RHODE ISLAND
DEPARTMENT OF ENVIRONMENTAL MANAGEMENT
OFFICE OF WASTE MANAGEMENT
235 Promenade Street, Room 380
Providence, Rhode Island 02908

November 14, 2019

RE **Remedial Action Work Plan Addendum**
Landfill Cap Grading Plan
Former Portsmouth Landfill
RAWP Modification

Modified Cap Plan
Former Kidd/Portsmouth Landfill
 Park Avenue
 Portsmouth, Rhode Island
 Owner:
AP Enterprises, LLC
 28 Teal Drive, Wakefield, Rhode Island 02879

Final Grading Modifications

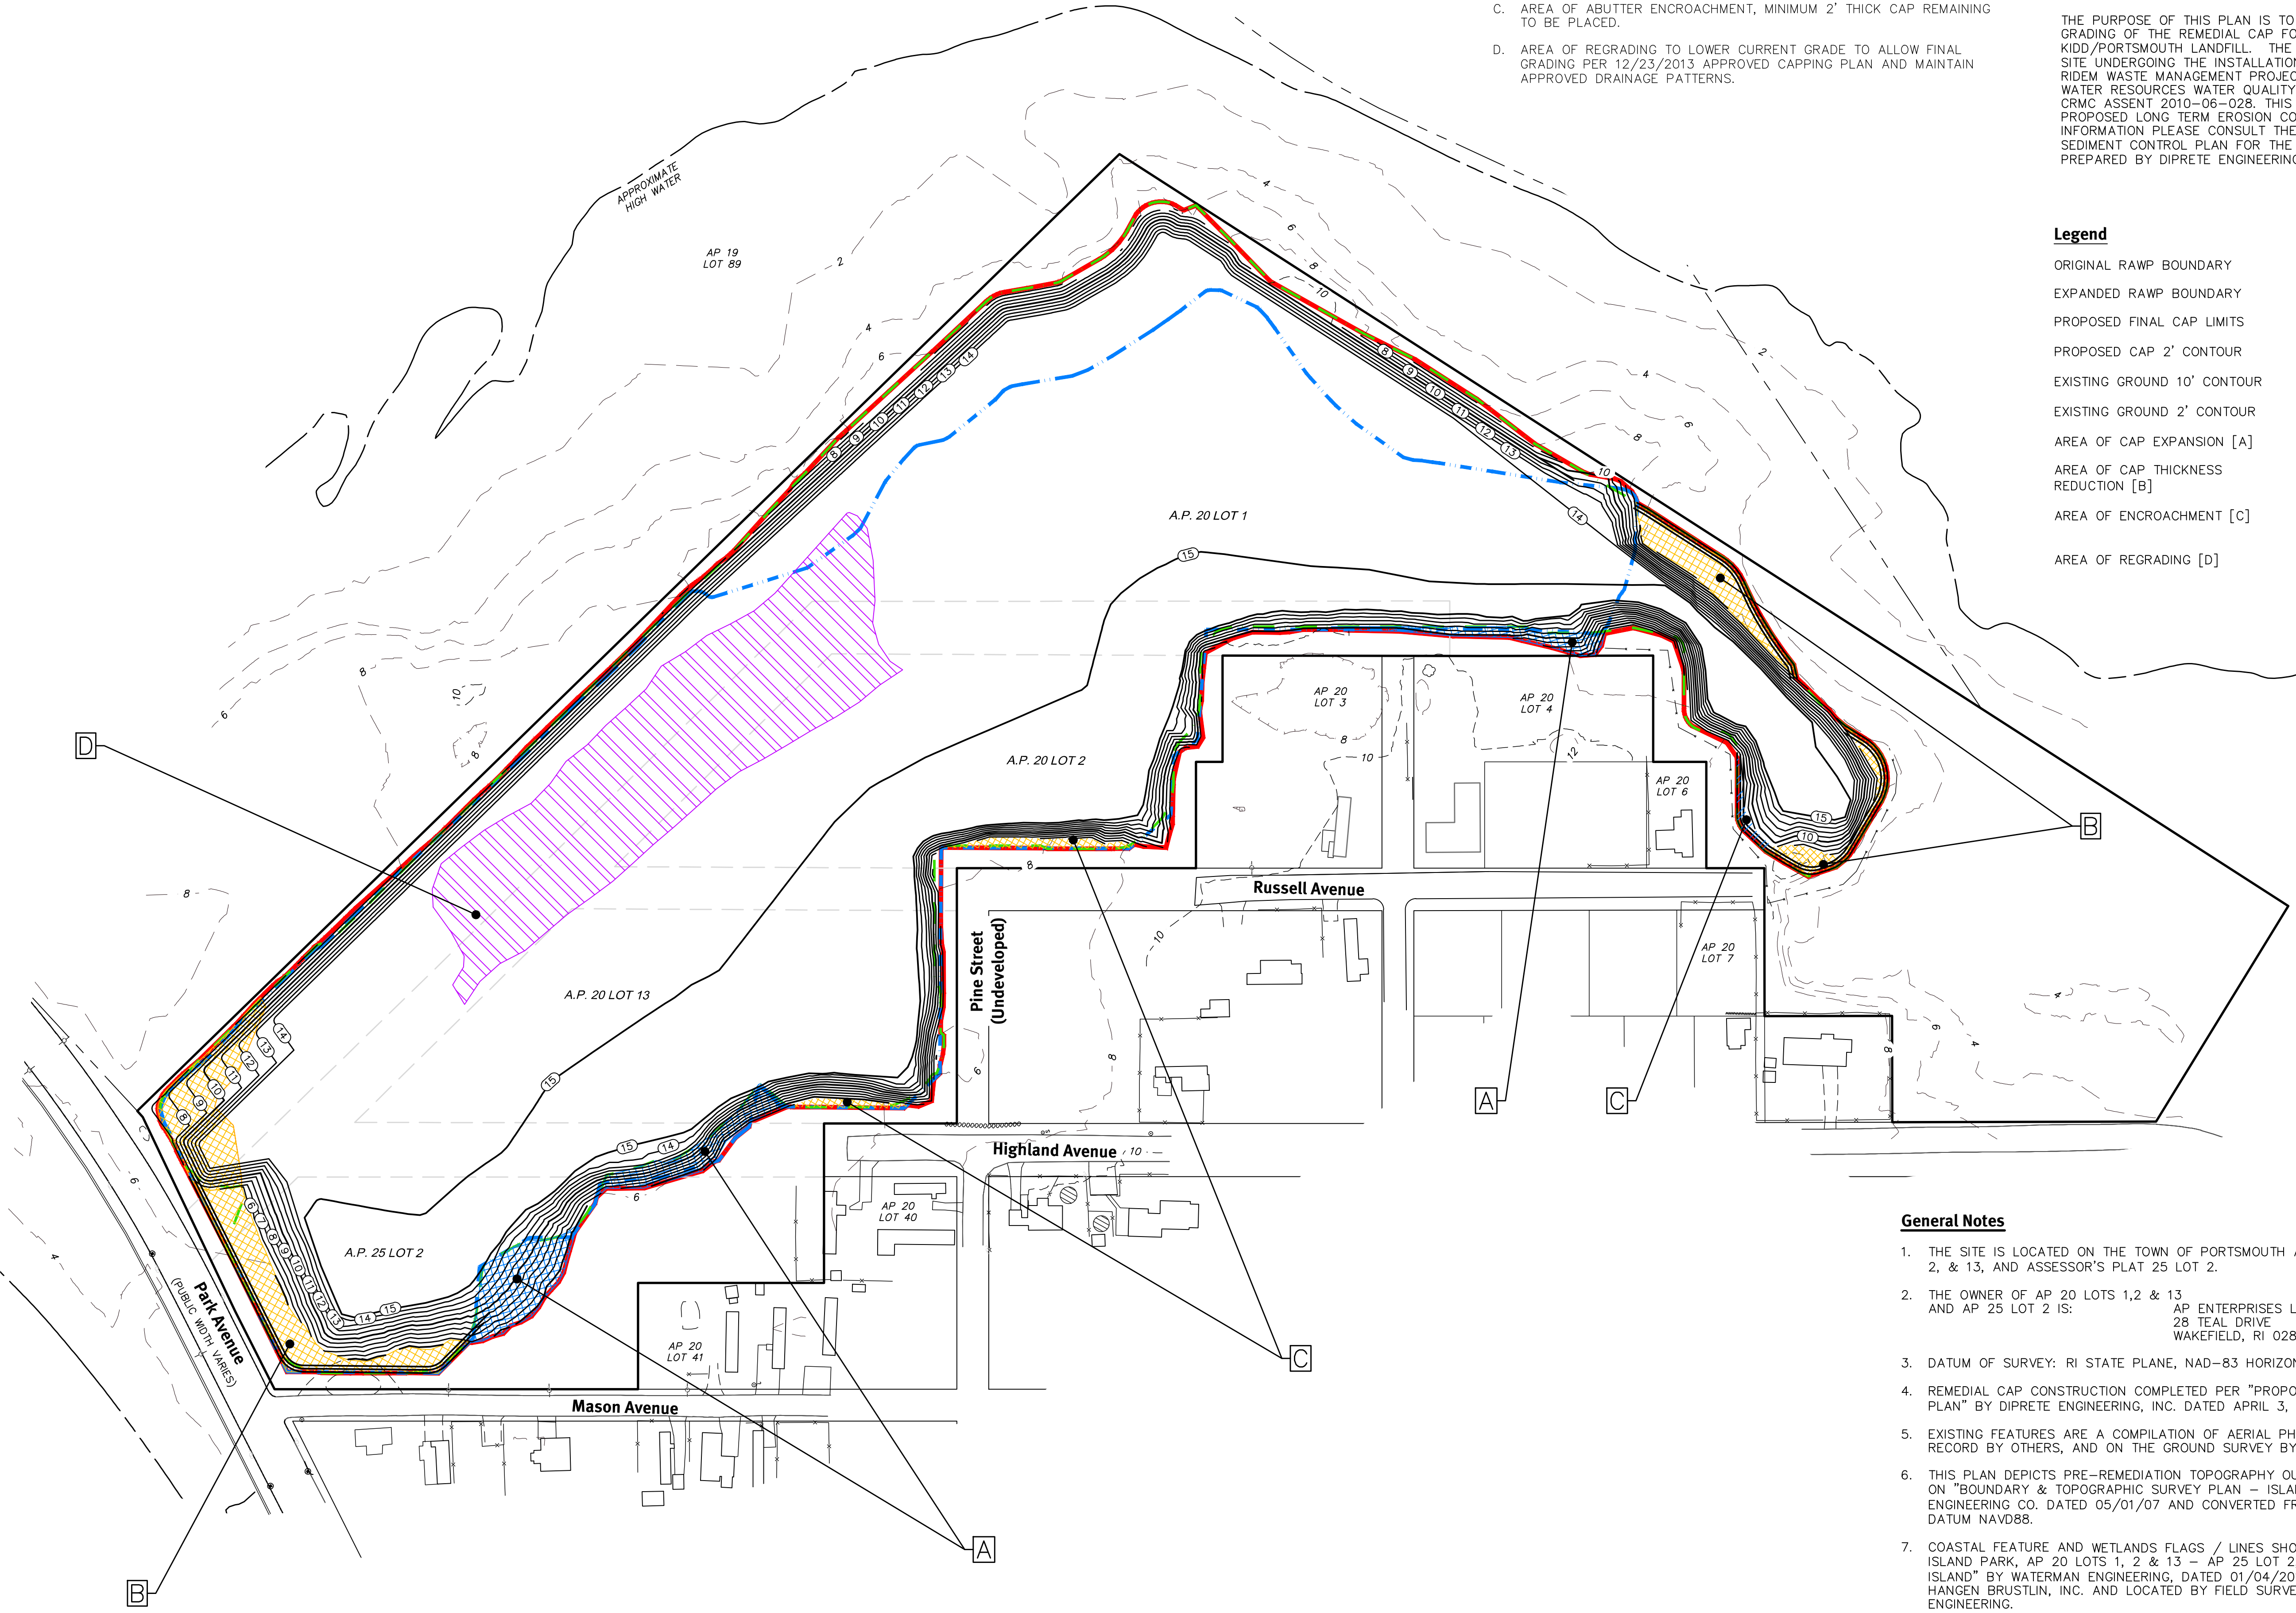
1. The overall slope meets the slope requirements of 3-33% on all areas of the landfill.
2. The cap meets the Department's requirements of 2-feet of clean soil with the top six (6) inches supporting vegetative growth. This is required even in areas labeled on the DiPrete plan as 'A-D'.

3. All soil must meet the Residential Direct Exposure Criteria (RDEC) and have compliance sampling data submitted to the Department for all new sources of material. The quarterly updates sent to the Department must include all sampling results as well as the quantity of material received. The Department has the right to ask for additional sampling on any capping material as deemed necessary.

5. The drainage patterns, locations and rates will remain the same as originally approved in the Department.
6. All activities, procedures, operations and schedules detailed in the RAWP, RAL, this RAL Addendum and the RAWP Modification request are strictly adhered to. Any significant changes to the RAWP shall be pre-approved by the OWM, and any minor changes shall be reported to the Department by telephone within one (1) day and in writing within five (5) working days.
